**Re: Dominican Valley Residential Development Applications –
Inapplicability of Builder’s Remedy**

**Re: File No: PA23-002 (PLAN23-075)
Preliminary Application for Dominican Residential Development - Proposal A
(APN 015-163-03)**

SUBJECT: Planning File #PLAN23-075 – Pre-Application: 29 Units Dominican Site (a)

SHEET
C1
1 OF 6
22-192

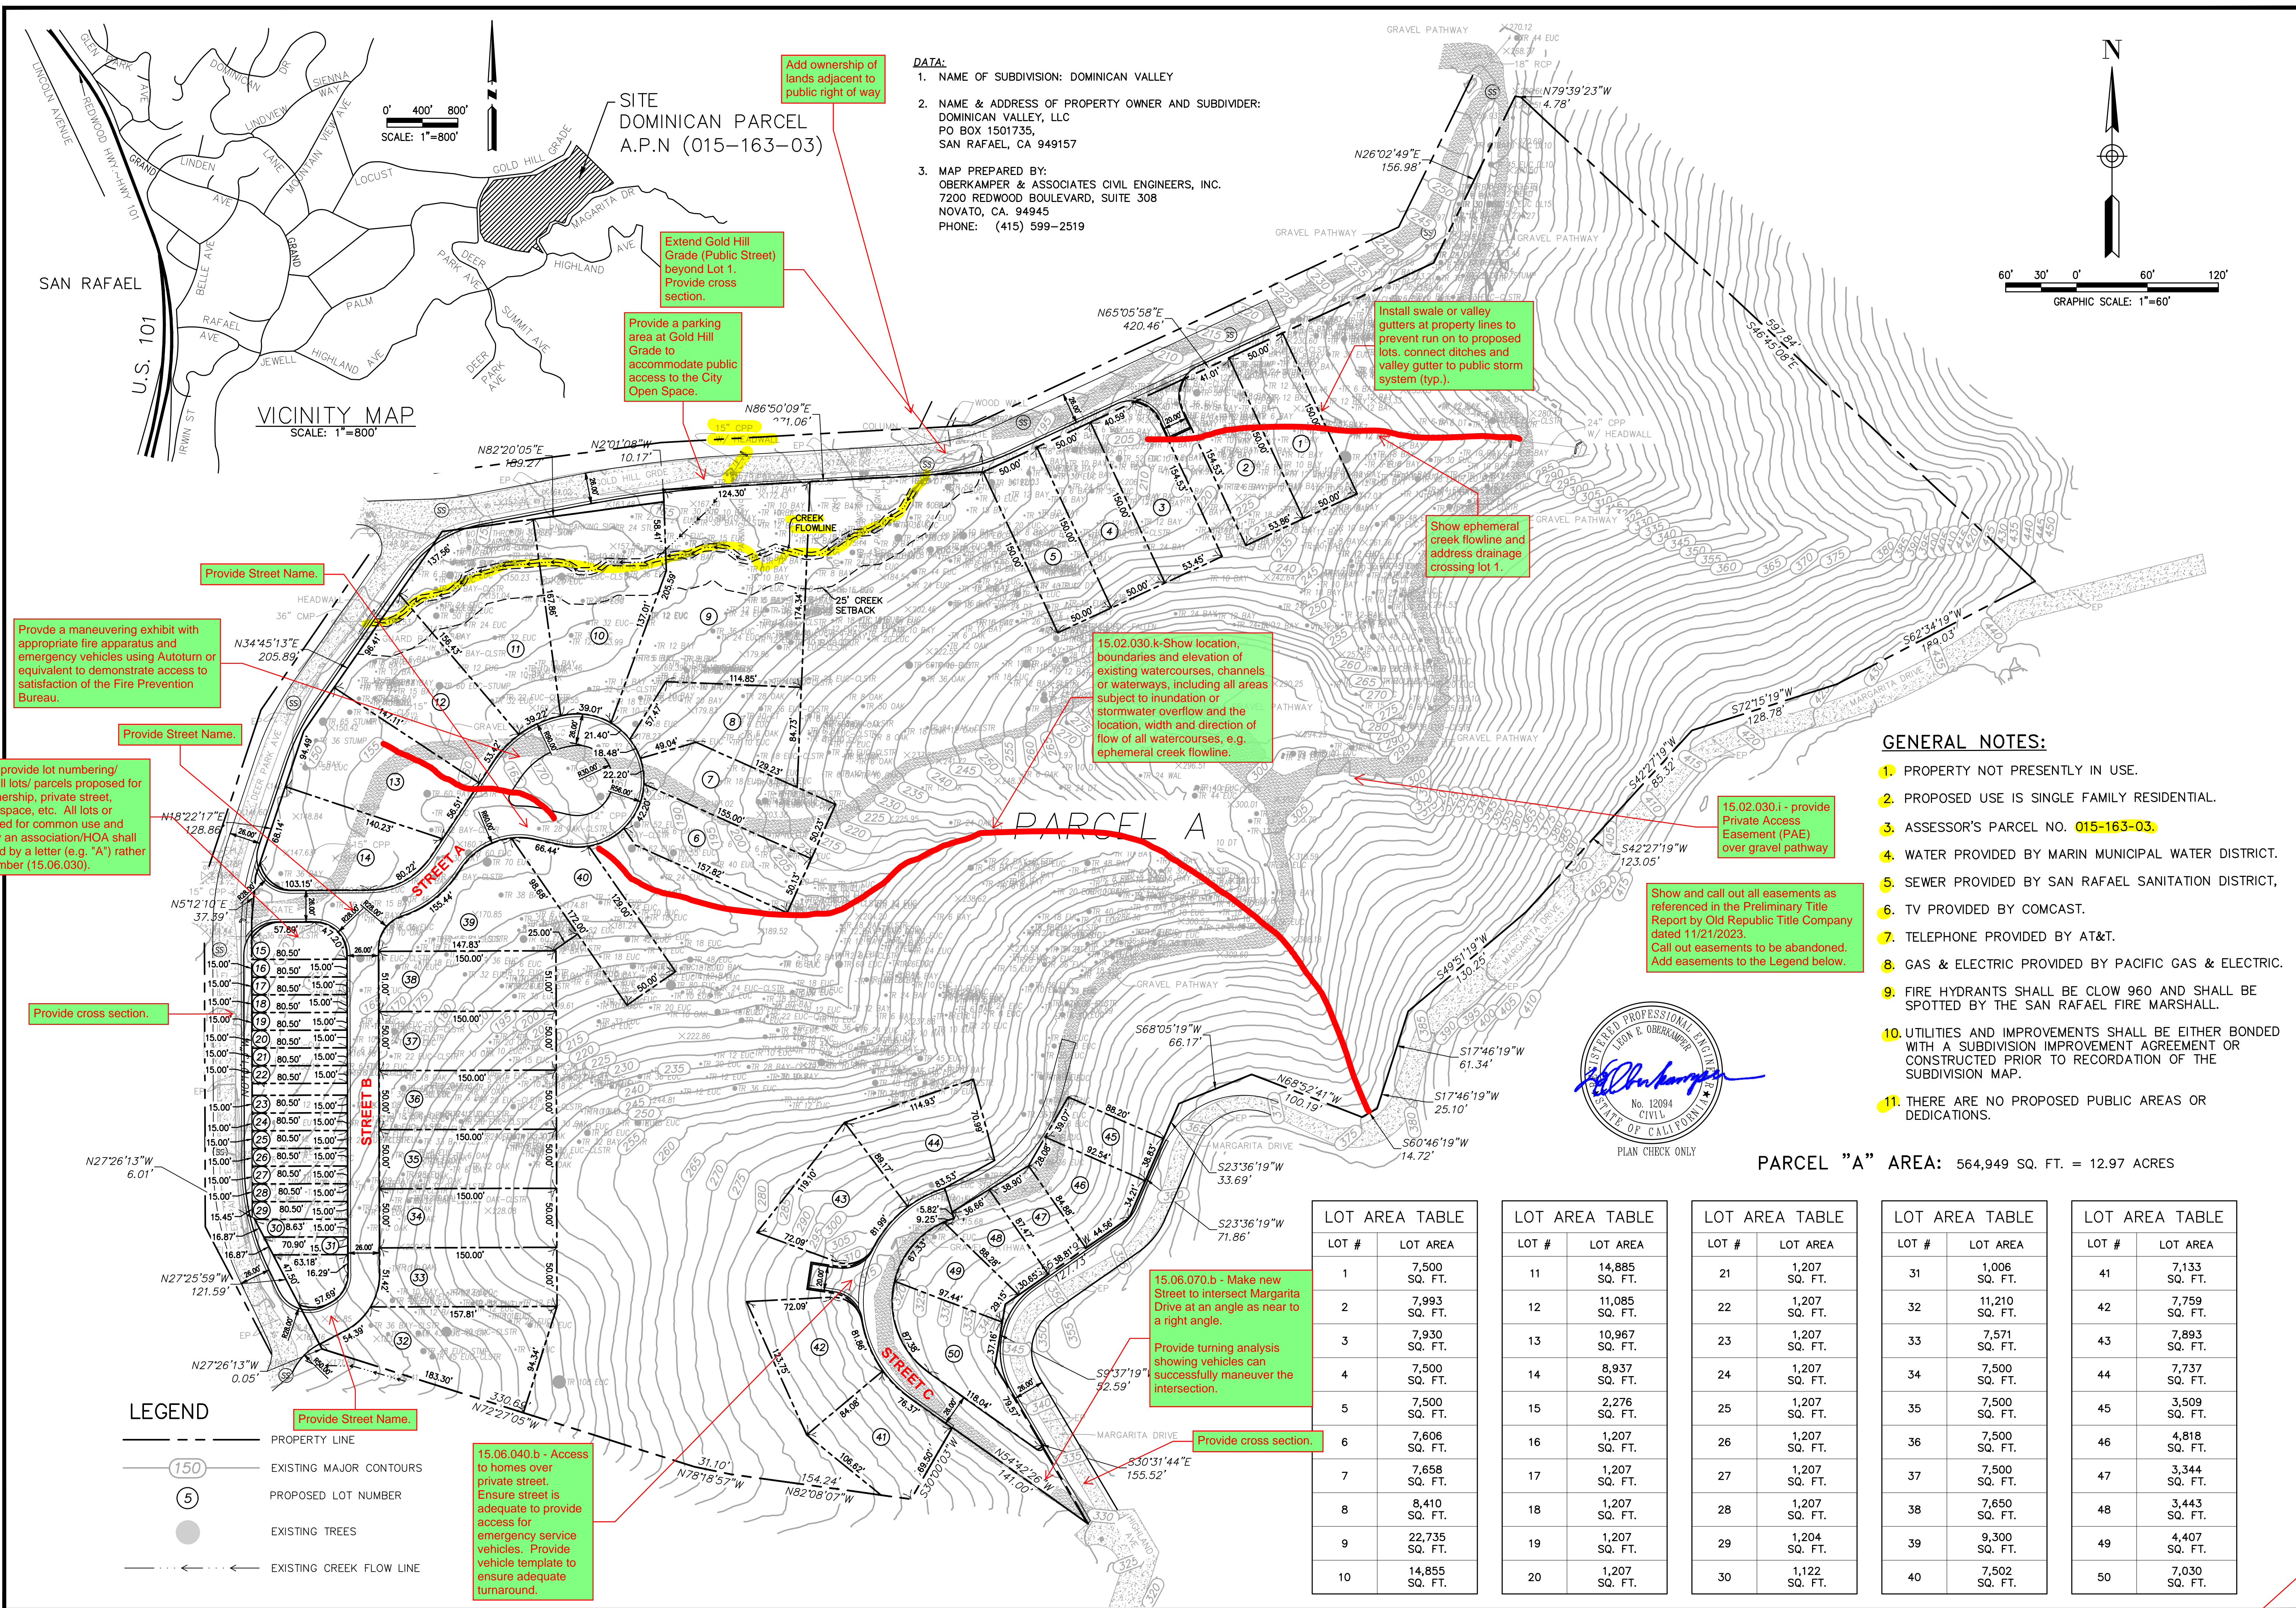
Provide sheet Index

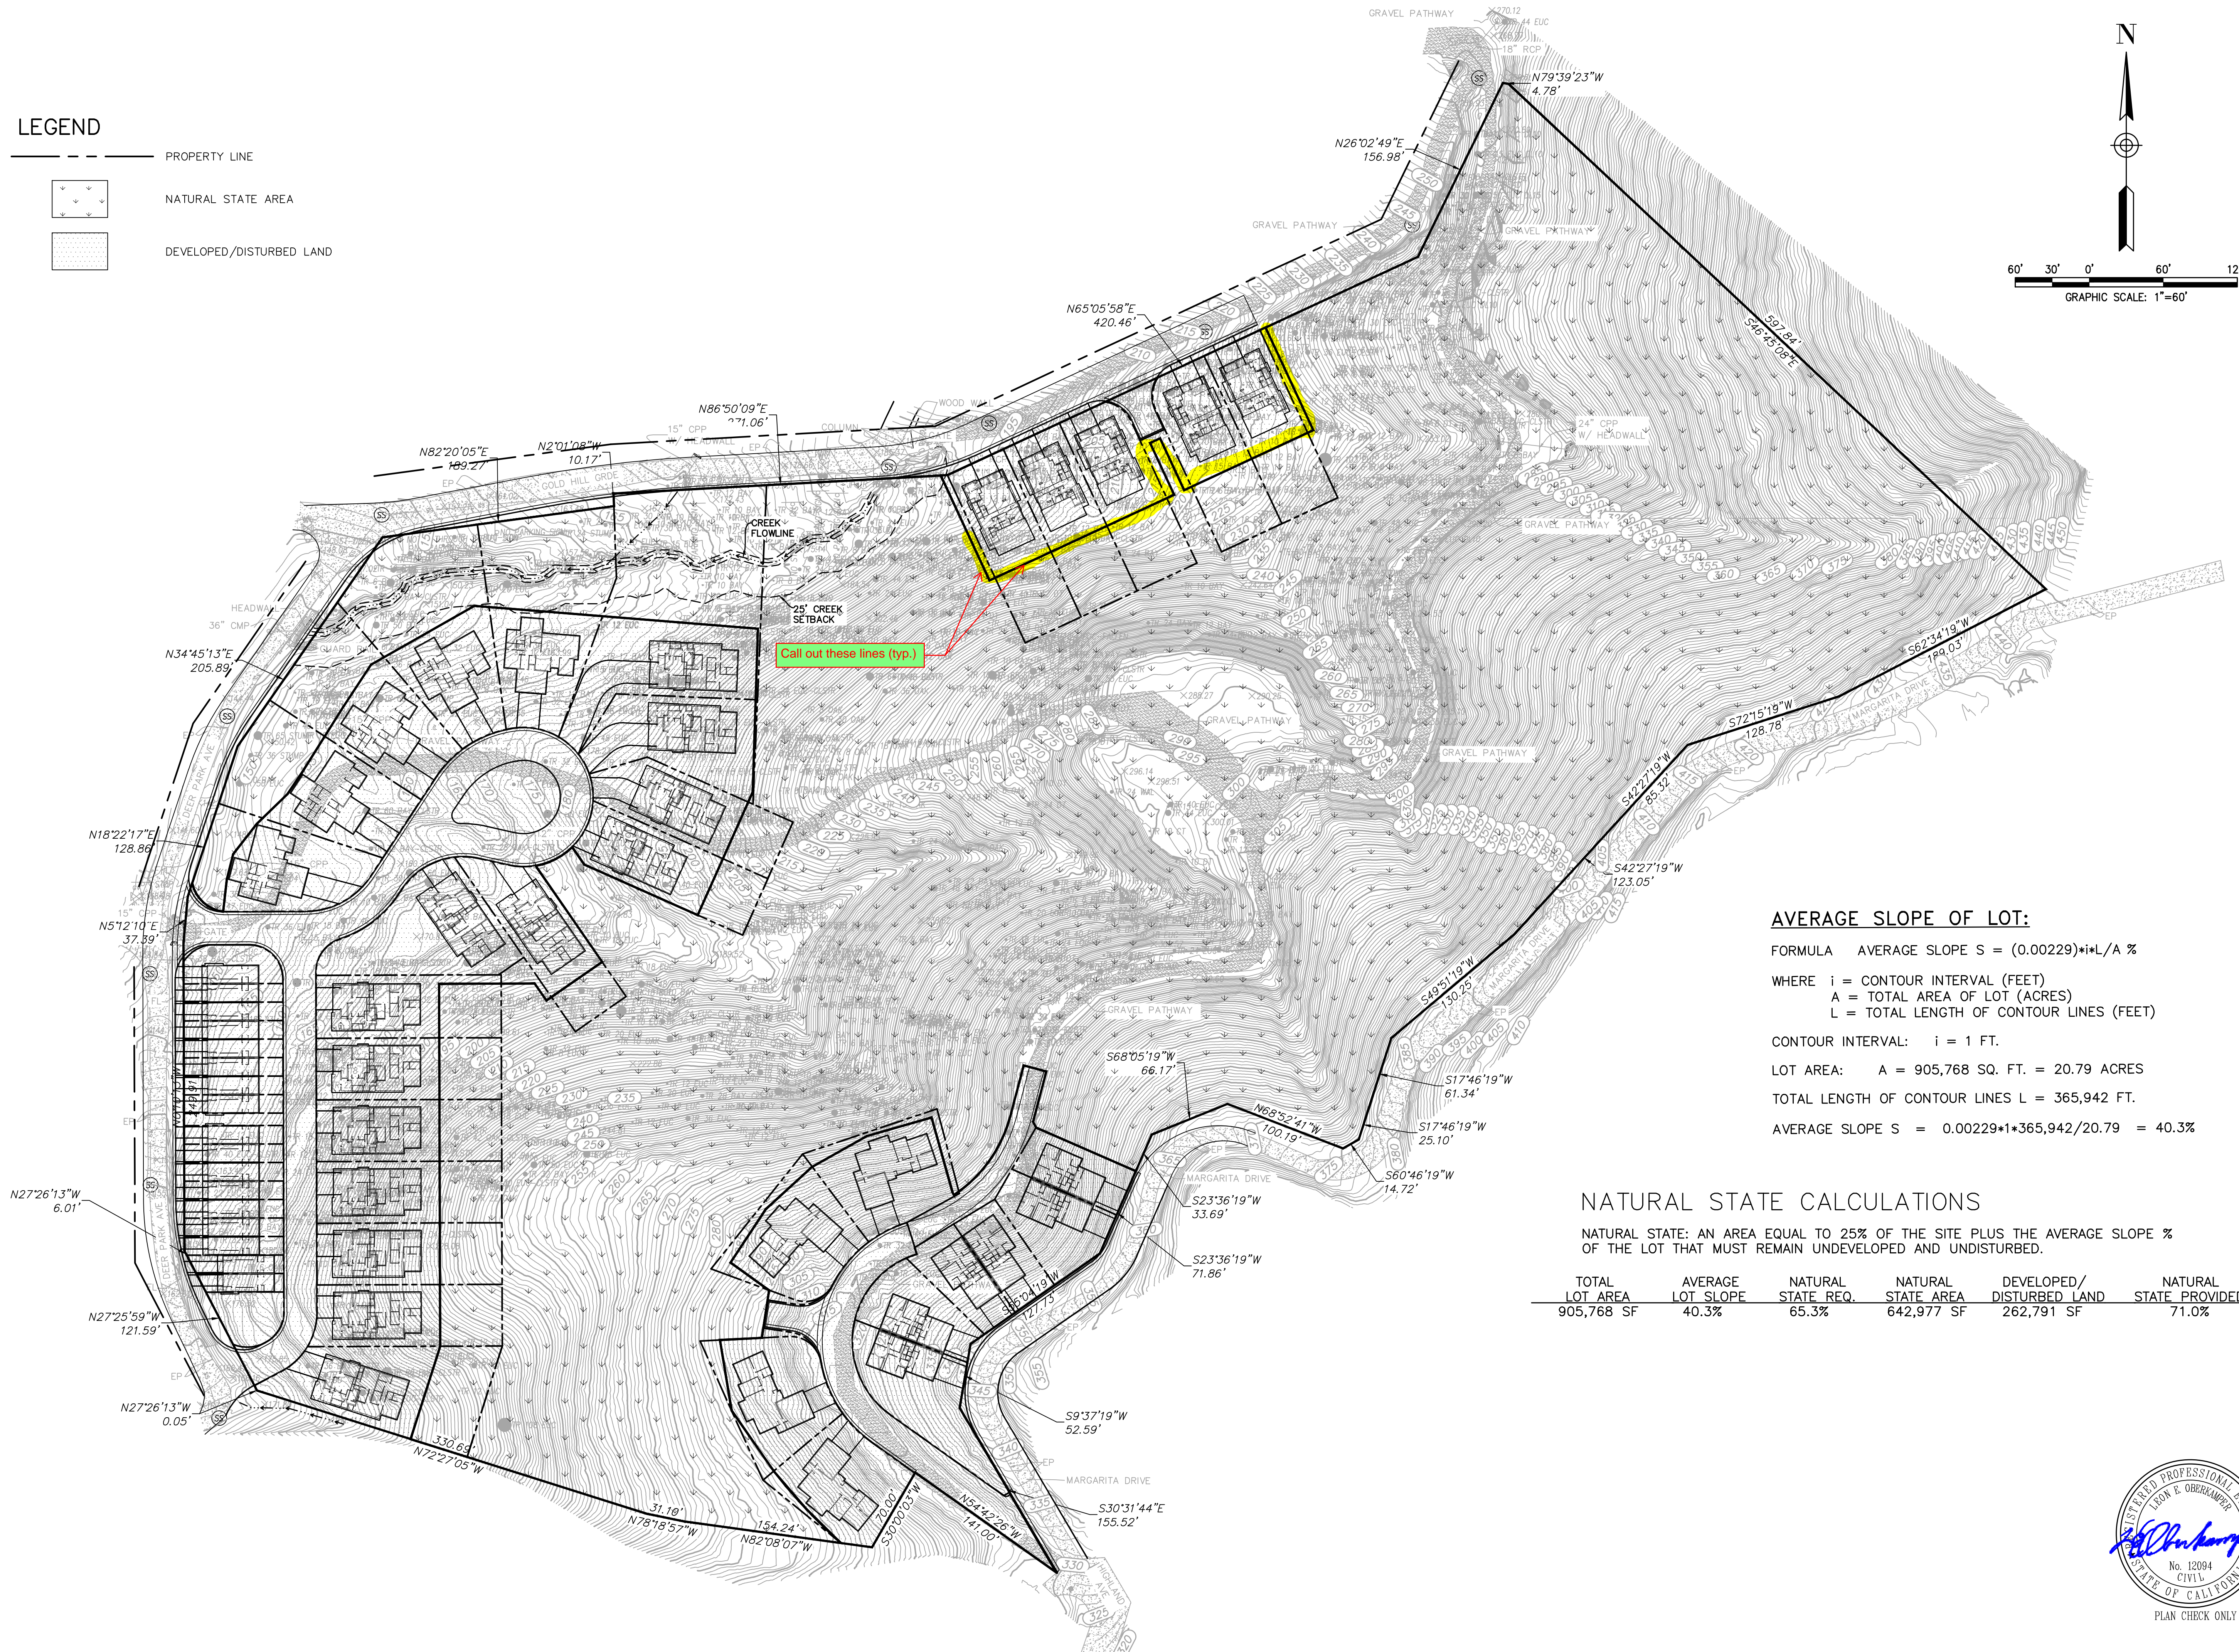
Make Sheet C2 Title Sheet for the Tentative Map.
